UN/SCETDG/52/INF.3/Add.1 UN/SCEGHS/34/INF.3/Add.1

Use of the Manual of Tests and Criteria in the context of the GHS : Part I (section 10)

Transmitted by the Chairman of the Working Group on Explosives

This document takes account of the amendments to the 6th revised edition of the Manual of Tests and Criteria agreed by the Working Group so far (see ST/SG/AC.10/C.3/102 paragraphs 95 to 97 and ST/SG/AC.10/C.4/66 paragraph 8).

Figure 10.2: PROCEDURE FOR PROVISIONAL ACCEPTANCE OF A SUBSTANCE OR ARTICLE IN THE CLASS OF EXPLOSIVES¹

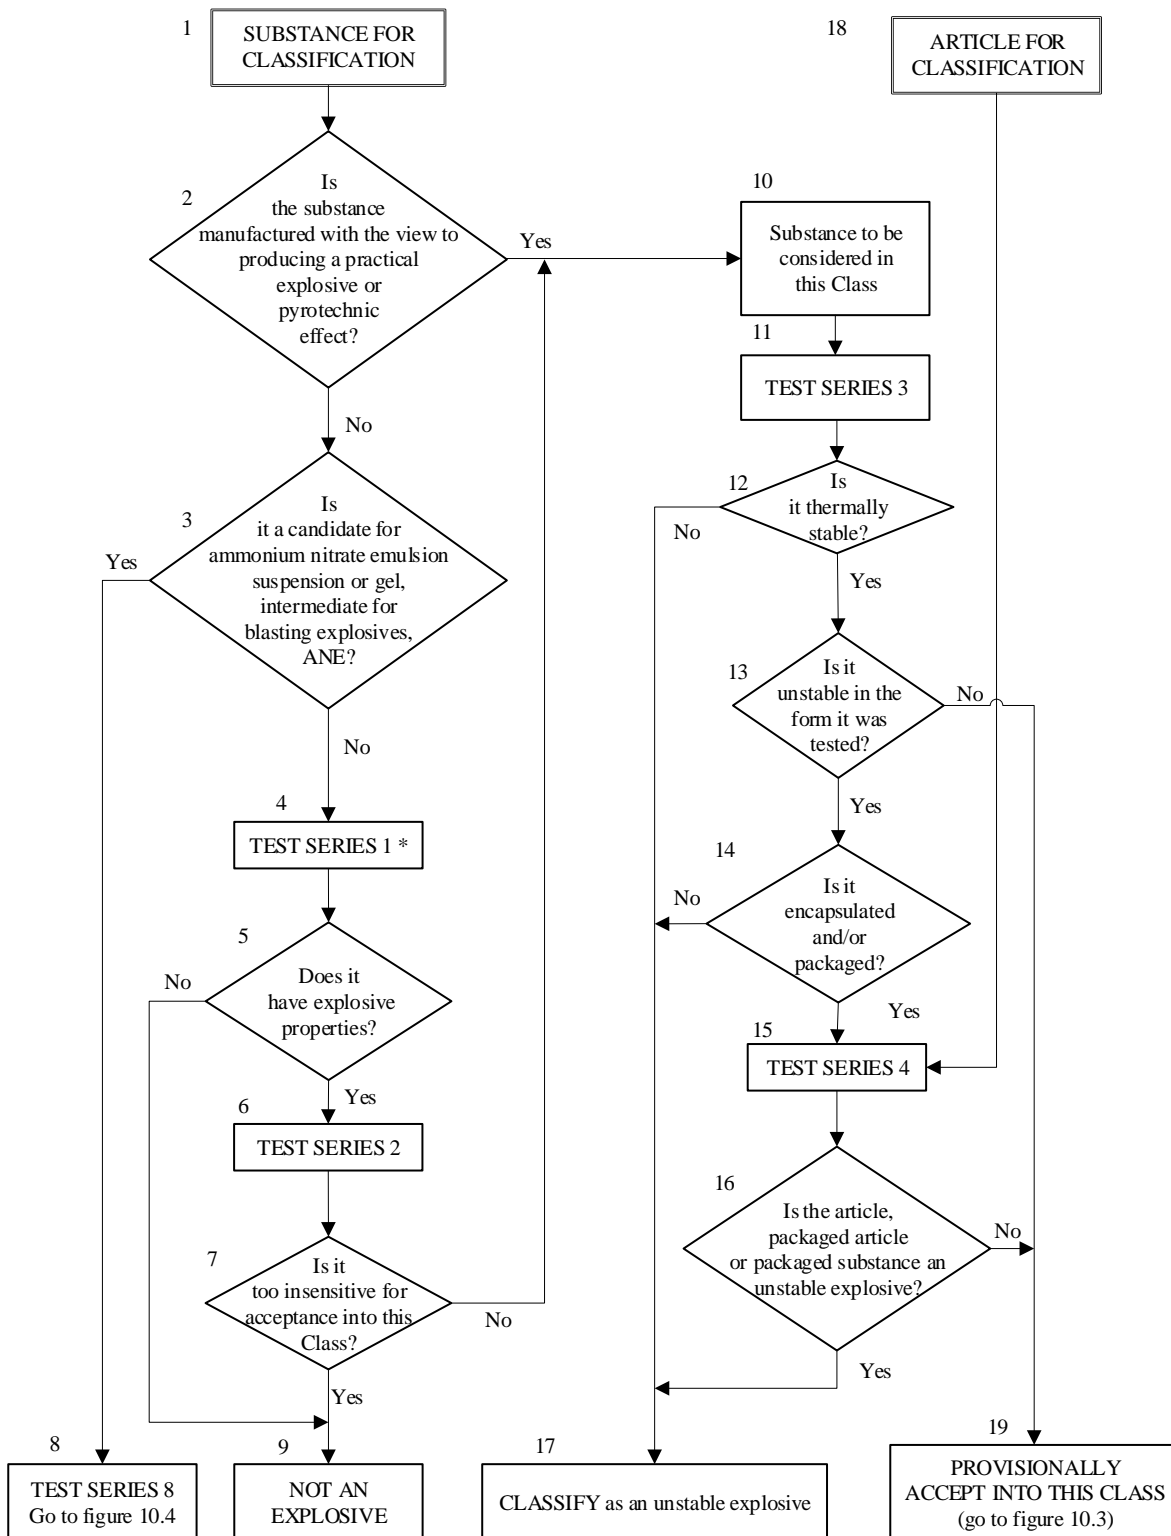
10.3.2.1 The test methods used for deciding provisional acceptance into the class of explosives ~~Class 1~~ are grouped into four series (~~Test series numbered~~ 1 to 4), and designed to provide the information necessary to answer the questions in Figure 10.2.

10.3.2.2 The question "~~Does Is it have an~~ explosive ~~substance~~ properties?" (box 45, Figure 10.2) is answered on the basis of national and international definitions of an explosive substance and the results of three types of Series 1 tests to assess possible explosive effects. The three types of test used are:

10.3.2.3 Series 2 tests are used to answer the question "Is ~~the substance~~ it too insensitive for acceptance into this class ~~1~~?" (box 67, Figure 10.2). In general the basic apparatus used is the same as that for Test Series 1 but with less stringent criteria, e.g. in the case of gap tests, the gap used is greater than zero. The following three types of test are used:

10.3.2.4 Test series 3 is used to answer the questions "Is ~~it the substance~~ thermally stable?" (box 12+10, Figure 10.2) and "Is ~~it unstable the substance too dangerous for transport~~ in the form ~~in which~~ it was tested?" (box 13+11, Figure 10.2). This involves tests for determining the sensitiveness of the substance to mechanical stimuli (impact and friction), and to heat and flame. The following four types of test are used:

10.3.2.5 Series 4 tests are intended to answer the question "Is the article, packaged article or packaged substance ~~an unstable explosive too dangerous for transport?~~" (box 16, Figure 10.2). Conditions which may occur during transport include high temperature and high relative humidity, low temperature, vibration, bumping and dropping. The two types of test to be carried out are:

Figure 10.3: PROCEDURE FOR ASSIGNMENT TO A DIVISION OF THE CLASS OF EXPLOSIVES †

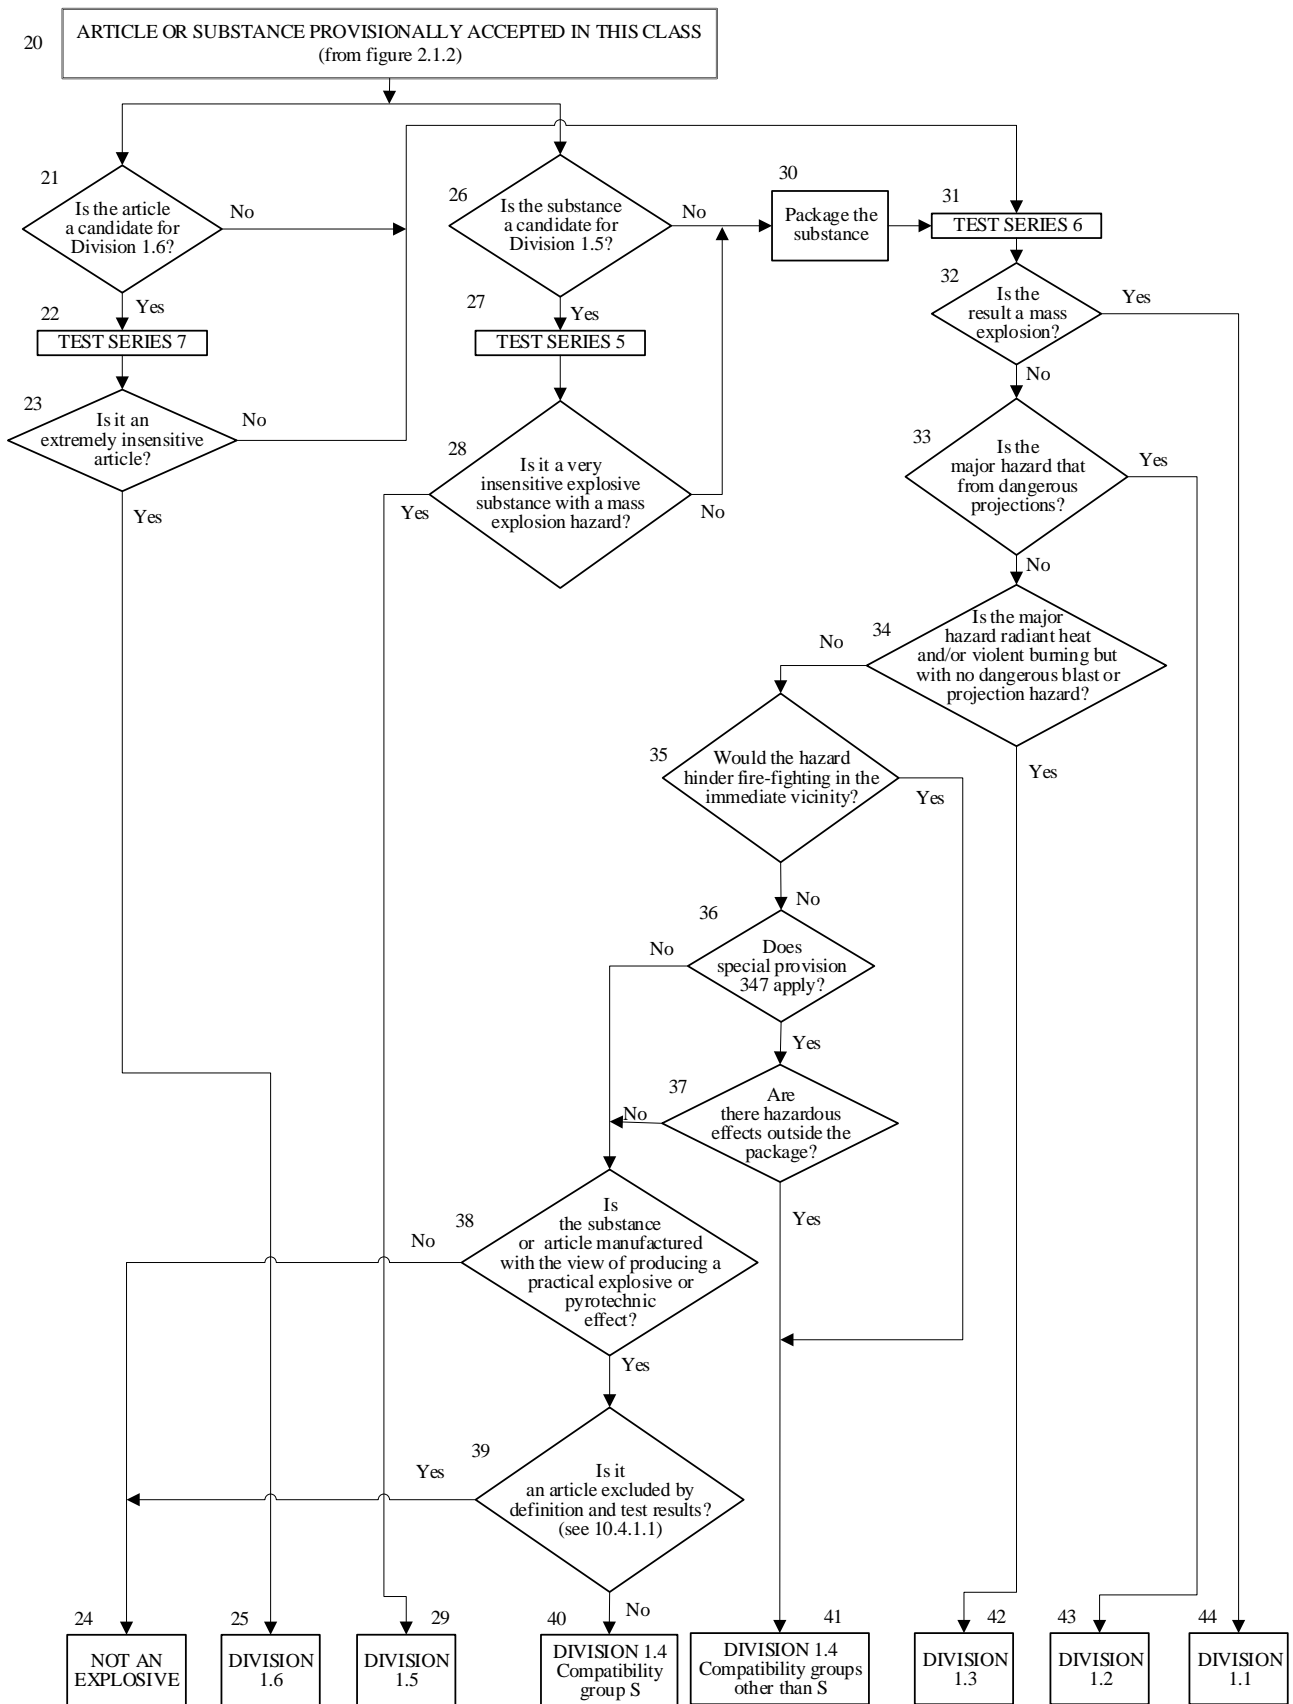
10.4.2.2 The results from three types of series 5 tests are used to answer the question "Is it a very insensitive explosive substance with a mass explosion hazard?" (box ~~28~~ ~~21~~, Figure 10.3). The test types are:

10.4.2.4 The question "Is it an extremely insensitive explosive article?" (box 23 40, Figure 10.3) is answered by series 7 tests and any candidate for Division 1.6 shall should pass one of each of the eleven types of test comprising the series. The protocol for determining the test requirements is given in Figure 10.5. The first six types of test (7 (a) to 7 (f)) are used to establish if a substance is an extremely insensitive substance (EIS). The purpose of these tests is to develop an understanding of the sensitivity of substance(s) contained within the article, which informs and provides confidence in the article tests. The remaining five types of test (7 (g), 7 (h), 7 (j), 7 (k) and 7 (l)) are used to determine if an article predominantly containing an EIS may be assigned to Division 1.6. The eleven test types are:

Figure 10.7 (b): **PROCEDURE-FLOW CHART FOR THE PROVISIONAL ACCEPTANCE OF MUSK XYLENE IN THE CLASS OF EXPLOSIVES¹**

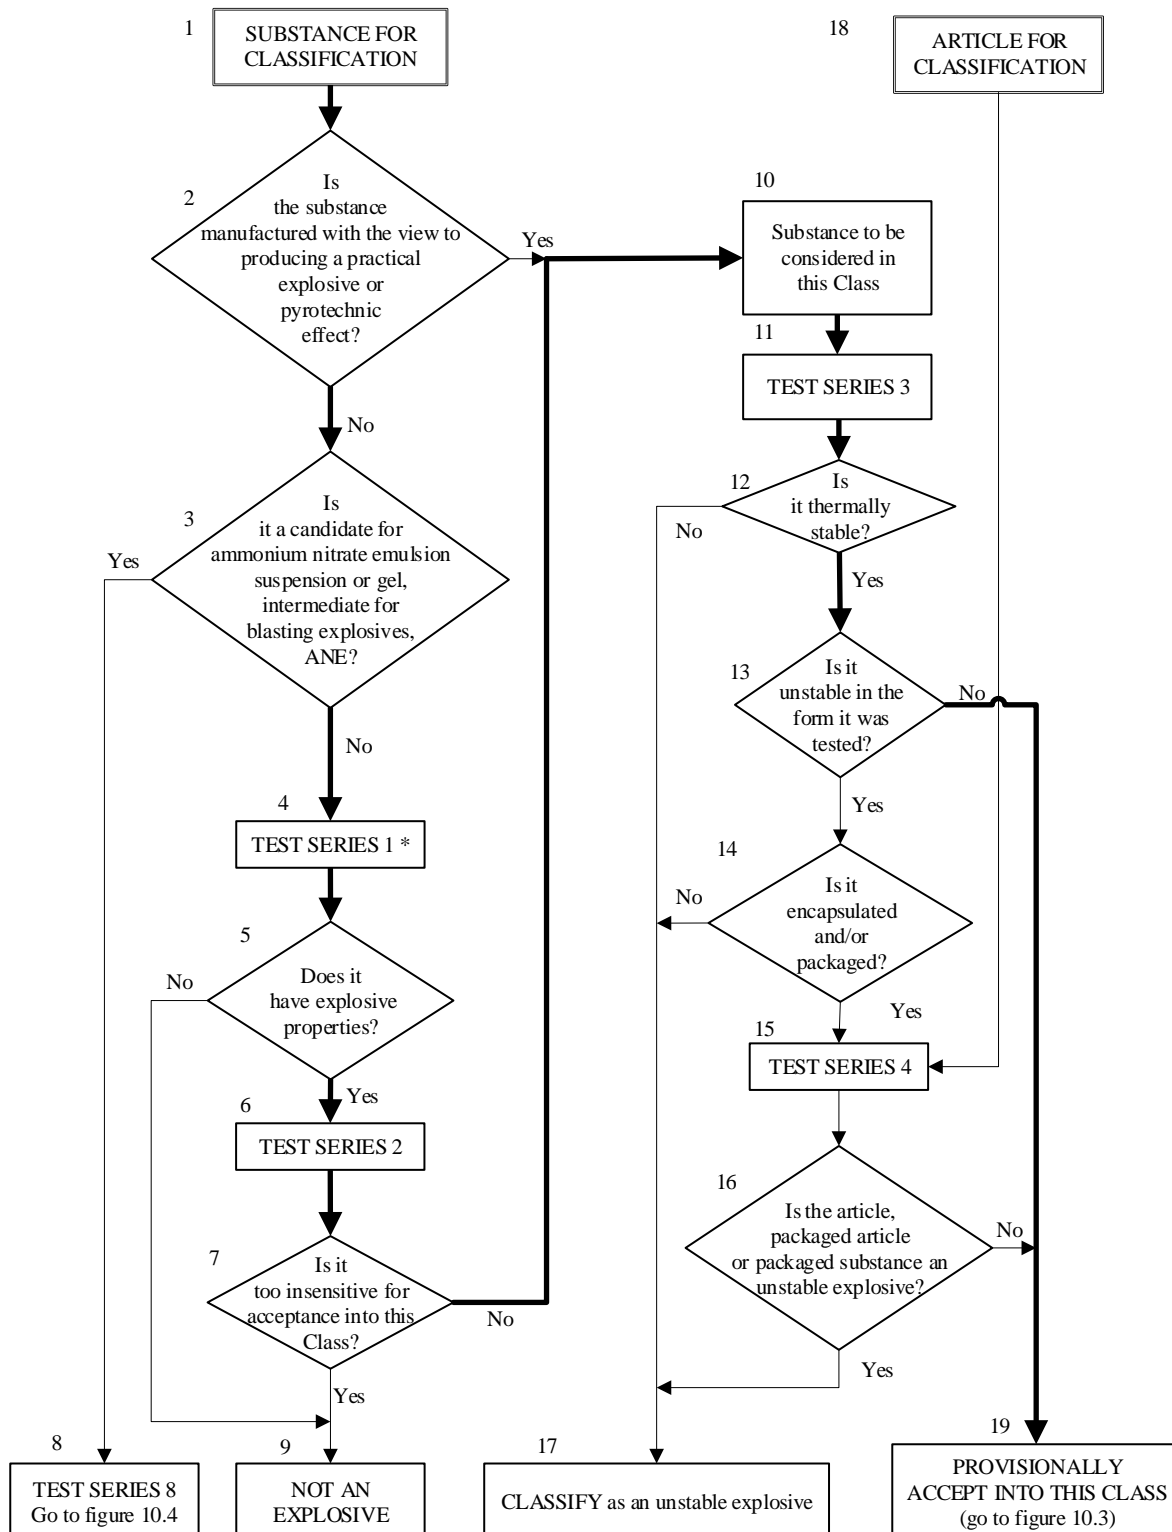
3.1	Answer	:	No
3.2	Exit	:	Go to Box 2a 3
4.	Box 2a3	:	Is it a candidate for ammonium nitrate emulsion, suspension or gel, intermediate for blasting explosives, ANE?

4.1	Answer	:	No
4.2	Exit	:	Go to Box 4
54.	Box 34	:	Test Series 1
54.1	Propagation of detonation	:	UN gap test (test 1(a))
54.2	Sample conditions	:	Ambient temperature

65.	Box 45	:	Is it an Does it have explosive substance properties?
65.1	Answer from Test Series 1	:	Yes
65.2	Exit	:	Go to box 56
76.	Box 5	:	Test Series 2

76.11	Observations	:	No ignition
76.12	Result	:	"-", no effect on ignition under confinement
76.13	Exit	:	Go to Box 67
87.	Box 67	:	Is the substance it too insensitive for acceptance into this Class 1 ?

87.1	Answer from Test Series 2:	No	
87.2	Conclusion	:	Substance to be considered for in this Class 1 (box 810)
87.3	Exit	:	Go to Box 911
98.	Box 911	:	Test Series 3

98.17	Exit	:	Go to box 1012
109.	Box 1012	:	Is it the substance thermally stable?
109.1	Answer from test 3(c)	:	Yes
109.2	Exit	:	Go to box 1113
1110.	Box 1113	:	Is the substance too dangerous for transport it unstable in the form it was tested?
1110.1	Answer from Test Series 3:	No	
1110.2	Exit	:	Go to box 1918
1211.	Conclusion	:	PROVISIONALLY ACCEPT INTO THIS CLASS 1

Figure 10.79(d): PROCEDURE FOR EXEMPTION OF MUSK XYLENE FROM THE CLASS OF EXPLOSIVES-1

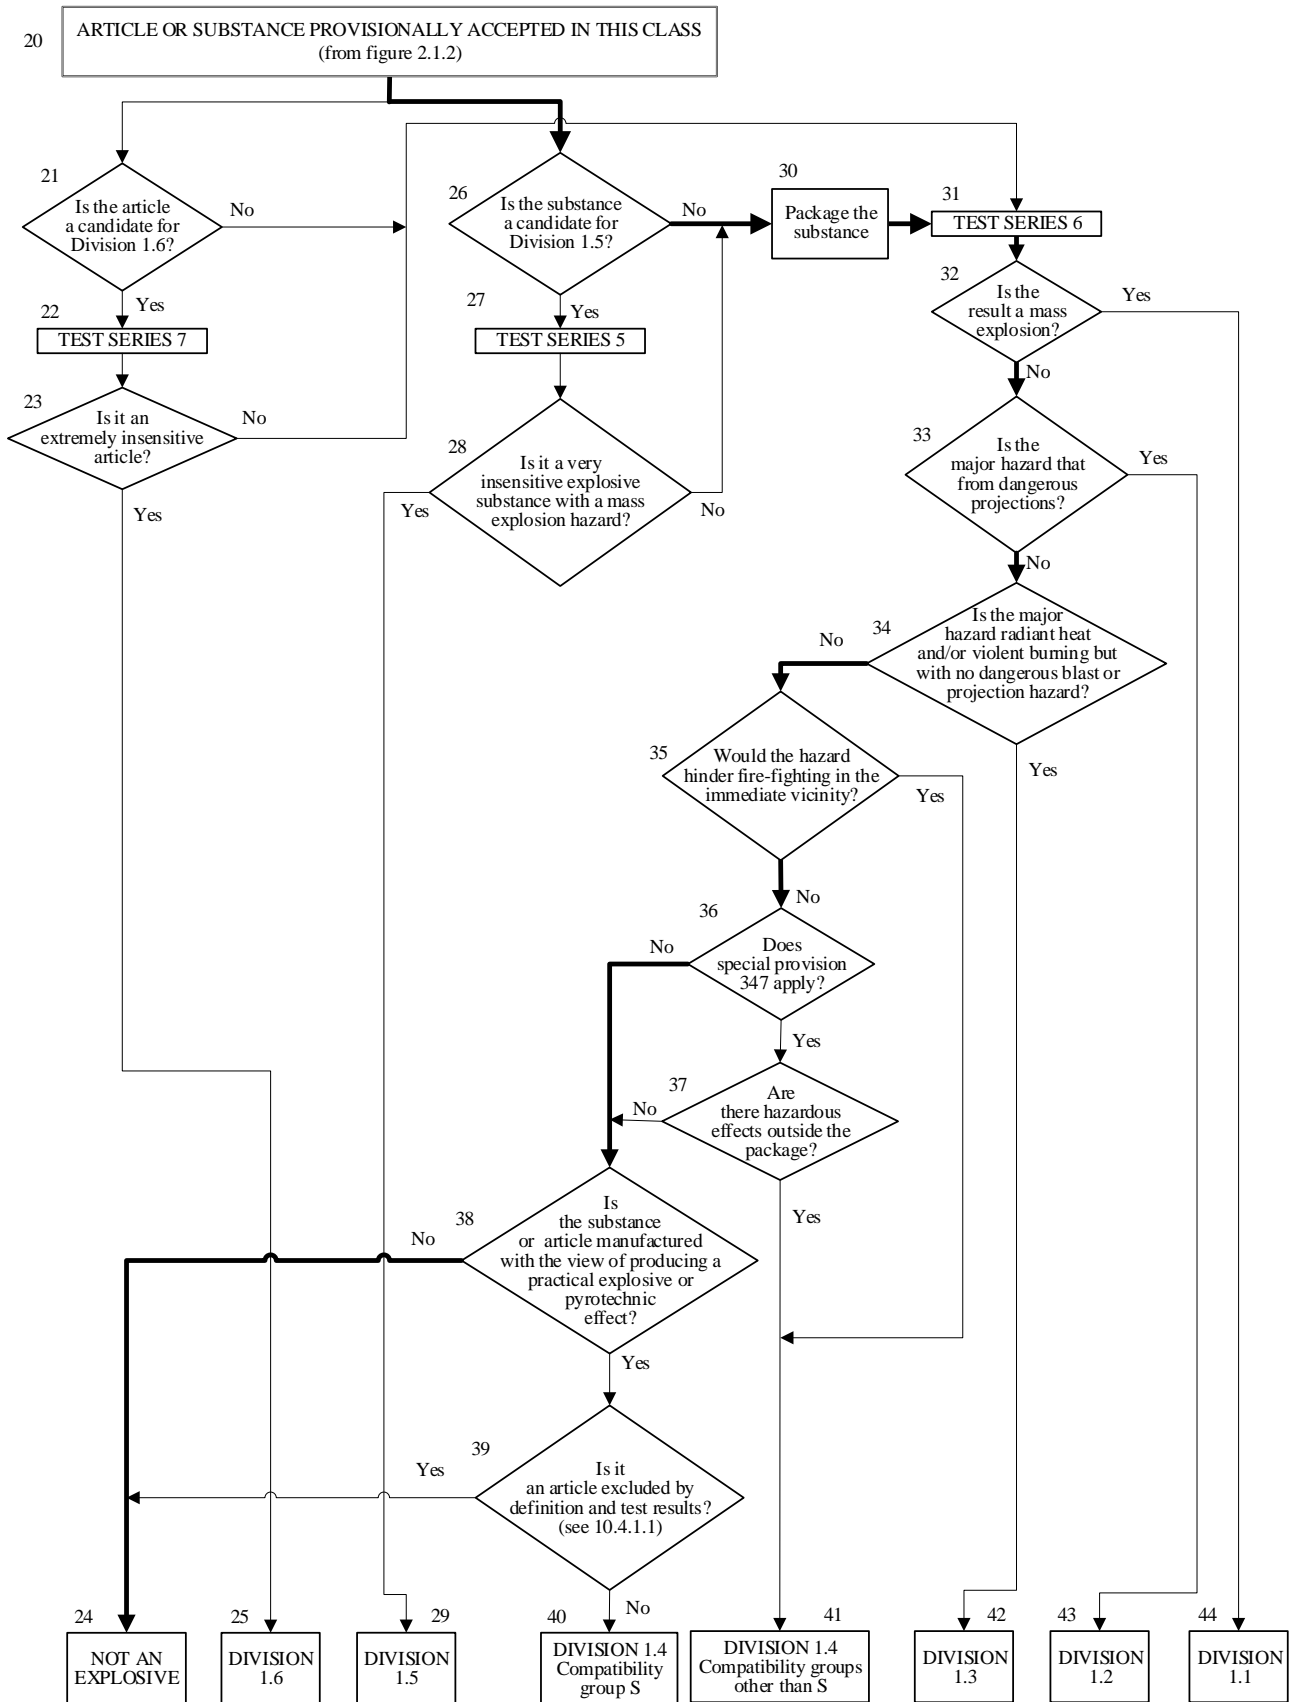
| 1. | Box 1926 | : | Is the substance a candidate for Division 1.5? |
| 1.2 | Result | : | Package the substance (box 2330) |
| 1.3 | Exit | : | Go to box 2531 |
| 2. | Box 2531 | : | Test Series 6 |
| 7. | Box 32a36 | : | Does special provision 347 apply? |

- 8.1 Answer : No
- 8.2 Exit : Go to box ~~38~~24
- 9. **Conclusion** : NOT ~~CLASS 1~~AN EXPLOSIVE
- 9.1 Exit : Consider for another class/division
